UNITED STATES PATENT AND TRADEMARK OFFICE

APPLICATION NO.	FILING DATE	FIRST NAMED INVENTOR	ATTORNEY DOCKET NO.	CONFIRMATION NO.
09/552,576	04/19/2000	William J. Oswald	9840-041-999	3976

Office Action Summary

FIGURE 2

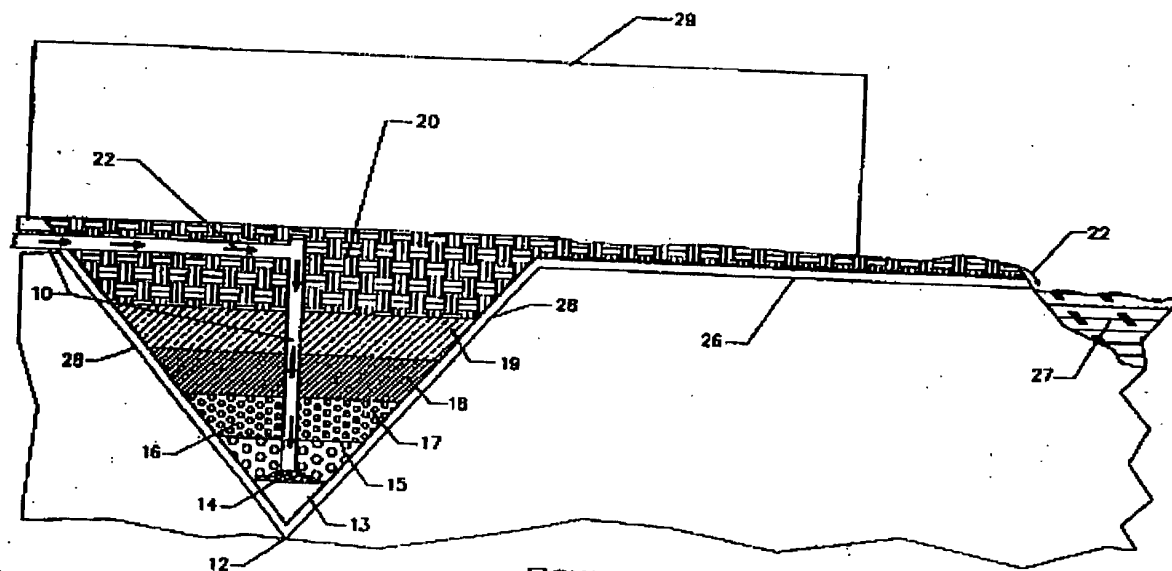
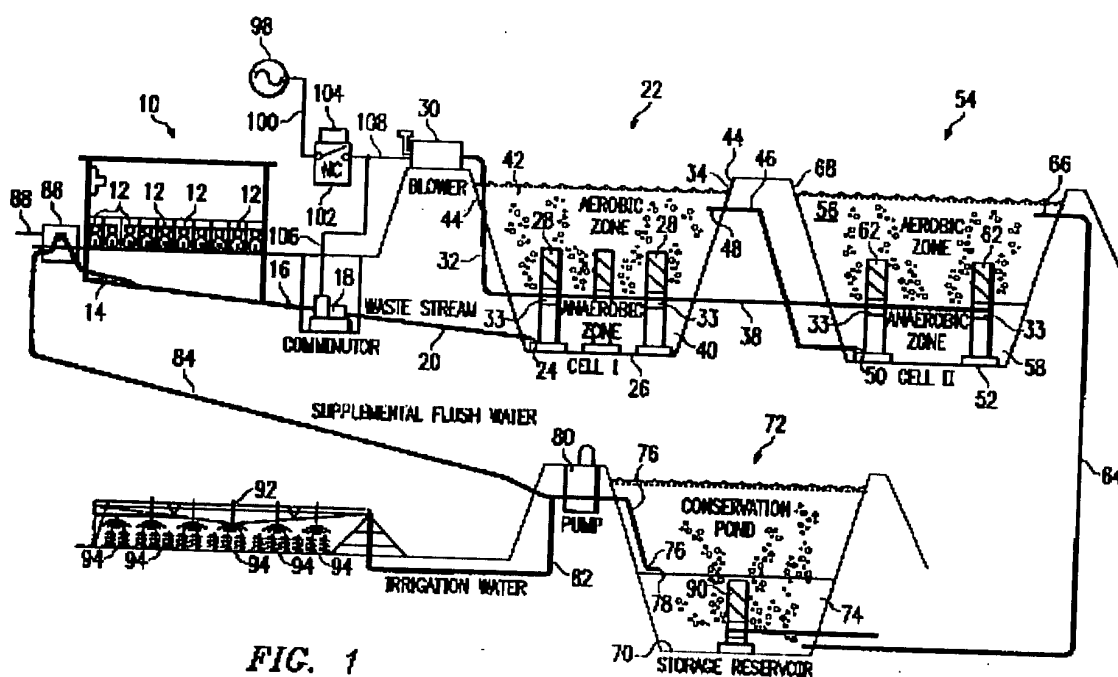
Claims 2, 34 are rejected under 35 U.S.C. §102(b) as anticipated by USP 4997568 to Vandervelde.

Vandervelde '568 at Fig. 2 describes a structure comprising an outer pond (defined by sand layer 20) larger in area and overlaying an anaerobic inner pond (layers 13 – 19). The skilled artisan would have understood that methane fermentation necessarily takes place at least at layer 13. Wastewater is fed through pipe 10 to the apex of the structure at the bottom of the anaerobic methane fermentation pit. Housing 29 is optional. The pond is "substantially open" insofar as the surface of the liquid contained by the outer pond is exposed to ambient air and light.

FIG. 8

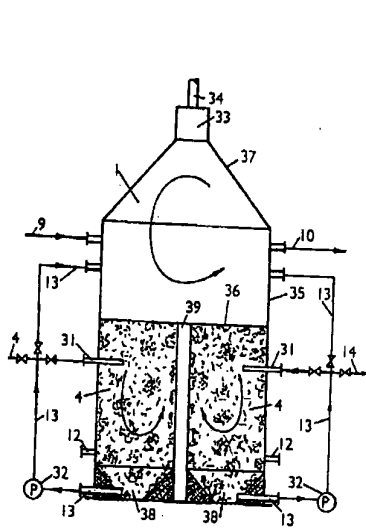
Claims 2, 15, 26 are rejected under 35 U.S.C. Sec. 102(b) as anticipated by USP 5616241 to Khudenko. Khudenko describes a pond (fig 8 or fig. 14) having a lower anaerobic methanogenic zone and an upper zone overlying the methanogenic zone. The pond is a vessel having a substantially open surface because methane and other gases can escape therefrom via submerged gas collector 37 (fig 14) and gas bell (conduit) 33, 34.
